TWO-WIRE FIELD TELEPHONE UK/PTC/404
MODIFICATION INSTRUCTIONS AND INDEX

TWO-WIRE FIELD TELEPHONE UK/PTC/404MODIFICATION INSTRUCTION No. 1

SUBJECT: Short line protectionINTRODUCTION

SUBJECT: Replacement of insulators for terminal postsINTRODUCTION

Fig 1

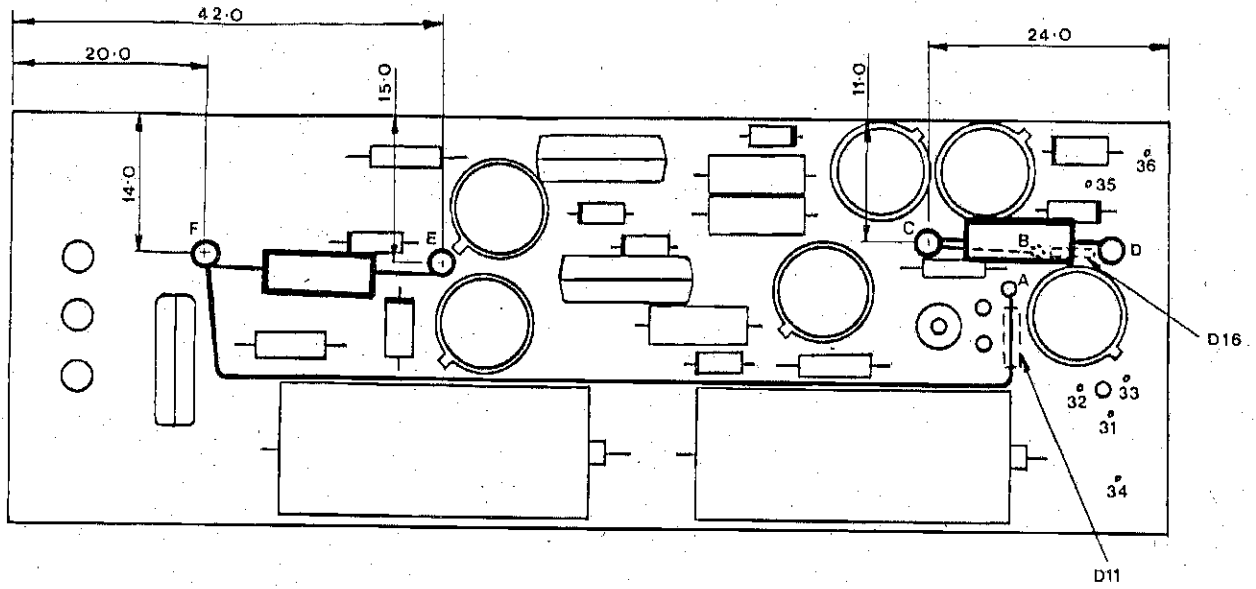
1 There have been several reported instances of transistors TR8 and TR12 in the ringing generator (board D) failing due to excessive current flowing. This occurs when the telephone is connected to a highly reactive load, such as a Tele J or UK/PTC/405, on short lines of less than 5 km. To overcome this defect, two current limiting resistors of 680 ohms, 2.5 W are to be fitted in place of diodes D11 and D16 on failure of TR8 and TR12. This instruction details the action required to fit these resistors.

9.6 Mark and drill 4 holes C, D, E and F using a No. 50 drill (1.8 mm dia) see Fig 1. Remove solder resist round holes D and E.

9.7 Fit terminal post 5940-99-956-9738 in 4 positions (C, D, E and F) and lock to board using centre punch on track side. Beware of damaging surrounding components.

9.8 Fit terminal post 5940-99-624-6744 in position A from track side.

9.9 Cut to size, fit and solder pink wire between A and F (160 mm long, strip each end by 5 mm).

9.10 Cut to size, fit and solder T.C. wire link between B and C.

9.11 Fit and solder resistors between tops of terminals C-D, and E-F ensuring resistors do not touch the board or adjacent components. See Fig 2.

9.12 Solder pins to board where applicable. (Pins A, D and E).
